R09PX

FMVSS 110 Noncompliance Incorrect Spare Tire Pressure Data

RECALL

**Models Affected: Certain 2010 Model Year Micro Bird Single Rear Wheel Model Buses
Manufactured from August 31, 2005 through September 27, 2009**

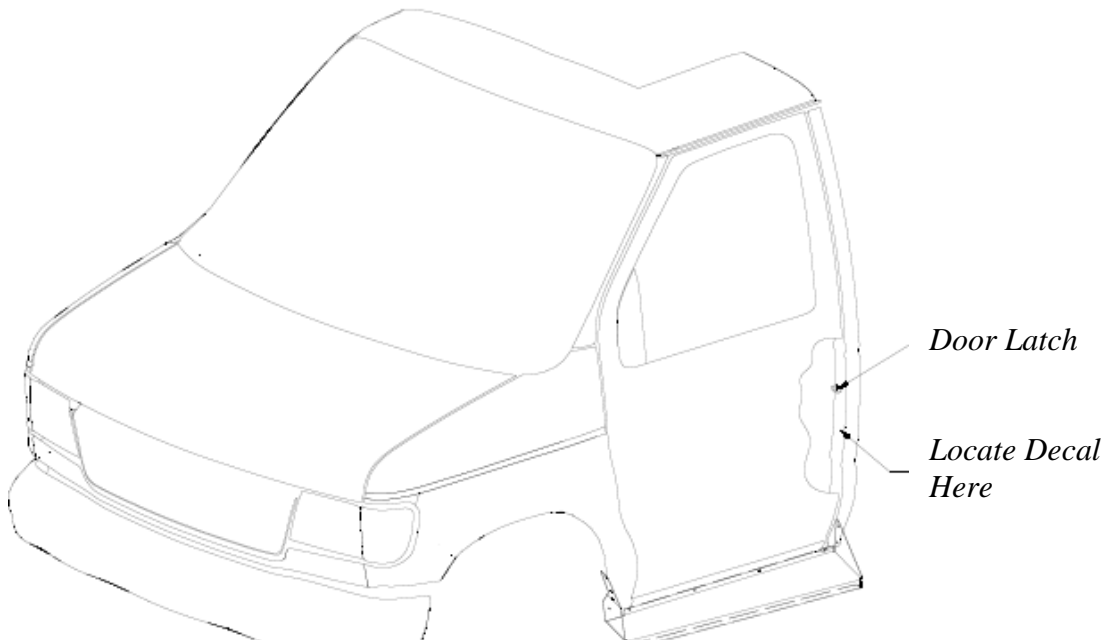
ISSUE

The tire and loading placard may not be in compliance with FMVSS 110 S4.3.4c regarding spare tire pressure information.

CORRECTIVE ACTION

A replacement decal indicating appropriate spare tire pressure as required by FMVSS 110 S4.3.4c will be provided to owners to install.
